Re: **Response to Request of Additional Information**
Project Name: MIVO Diplomat Center DD
Application/Petition No.: DCI2022-00027

Kimley Horn Reference No.: 045973000

**MIVO DEVELOPMENT GROUP
MIVO NORTH FORT MYERS PROJECT
RESIDENTIAL PLANNED DEVELOPMENT REZONE
LEE COUNTY, FL**

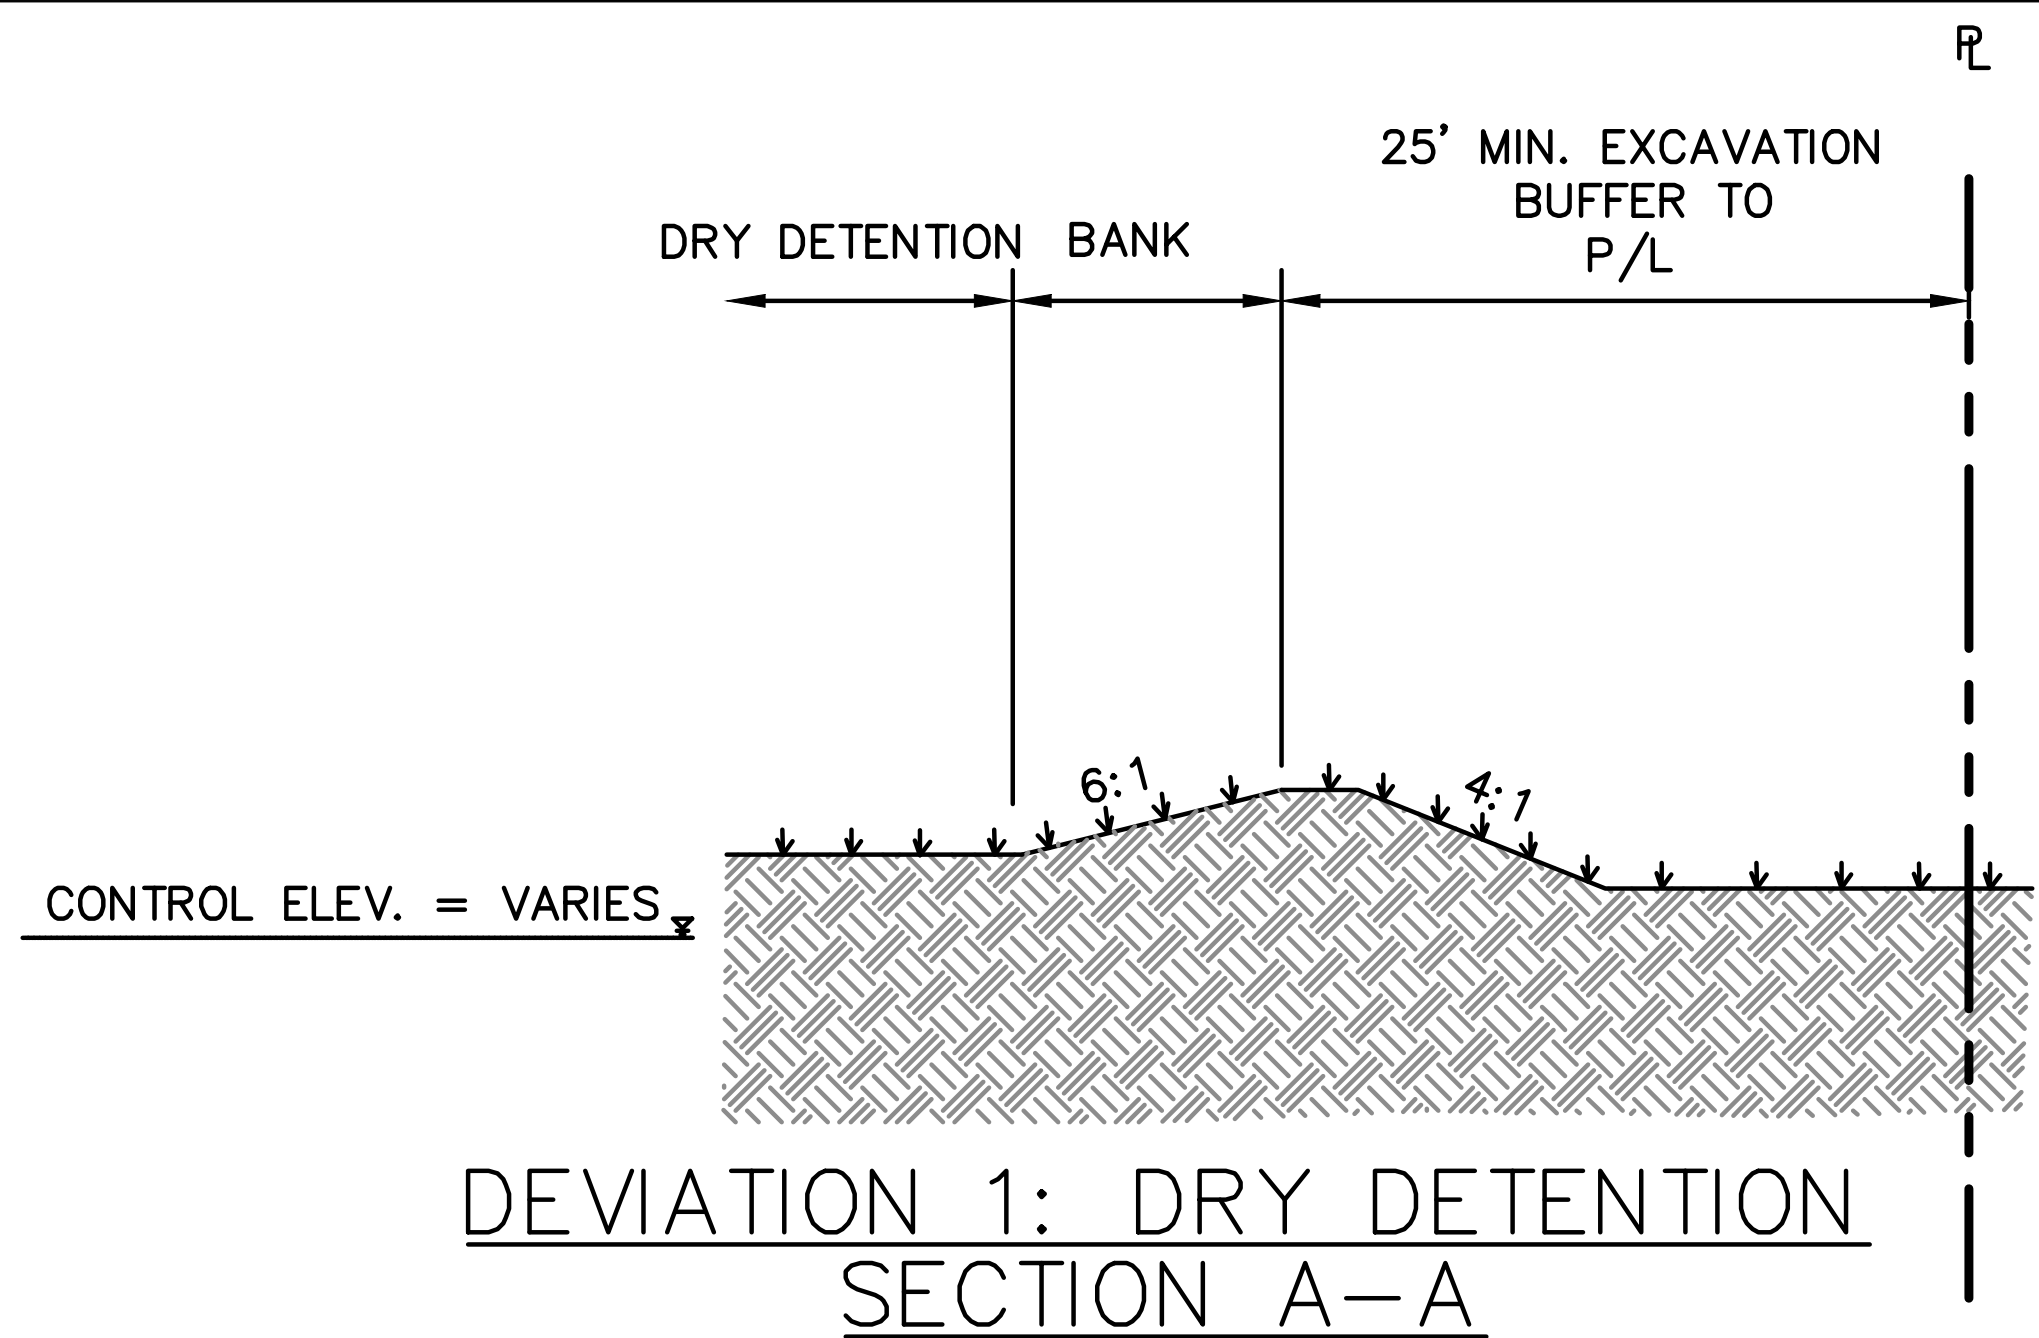
2. Per LDC Section 34-373(a)(6) the applicant must provide copies of the master concept plan in two sizes, 24 inches by 36 inches, and 11 inches by 17 inches in size. Both sizes of the master concept plan must be clearly legible, depict correct scale for the size of the drawing, and be drawn at a scale sufficient to adequately show and identify the information listed per LDC Section 34-373(a)(6). The current one-page MCP is not clearly legible and the cross sections and other details may need to be provided on another page.

Response: The MCP has been to include the cross sections, tables, etc. on a second page as requested. The MCP documents have also been provided in a 24"x 36" format as well as a 11"x17" format as requested.

DEVIATION 1: DRY DETENTION
SECTION A-A

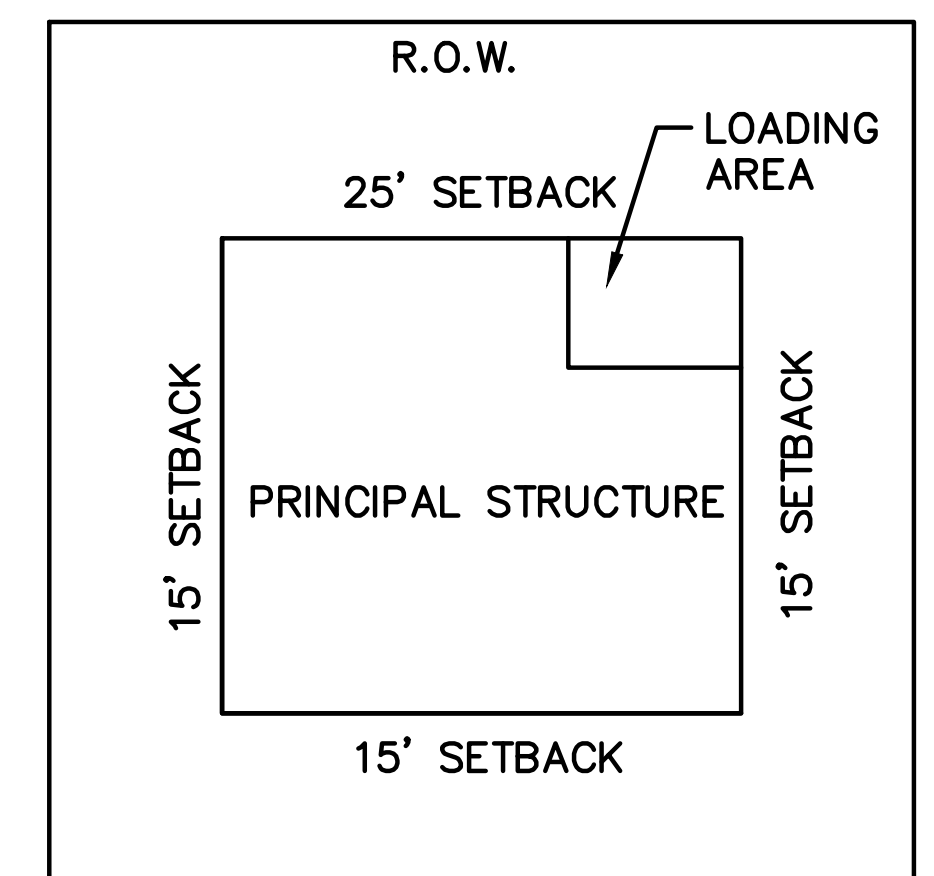
Deviation (1) is a request to deviate from Lee County LDC Section 10-329 (d)(1) which requires excavation to occur no less than 50 feet from existing property line and collector or arterial street, to allow for excavation to occur no less than 25 feet from existing property line. LDC Section 10-104 (a) allows for this deviation request.

This deviation is requested to allow 25-foot excavation activities from adjacent private property and along Cleveland Ave, where current conditions do not present a risk to the public's health, safety, and welfare. The stormwater detention areas affected by this requirement are proposed in locations where abutting either an existing swale or drainage canal allowing for a proper buffer thus not creating any concern with excavations up to 25' within property lines or right-of-way lines in reference to existing or proposed structures. In addition, due to the limited access points, geometry of property, and in order to maximize development area, stormwater detention areas should be considered along the property boundaries of the site which pushes them closer to the property line. Proper protection along areas of concern will be addressed during the Development Order process meeting LDC requirements.
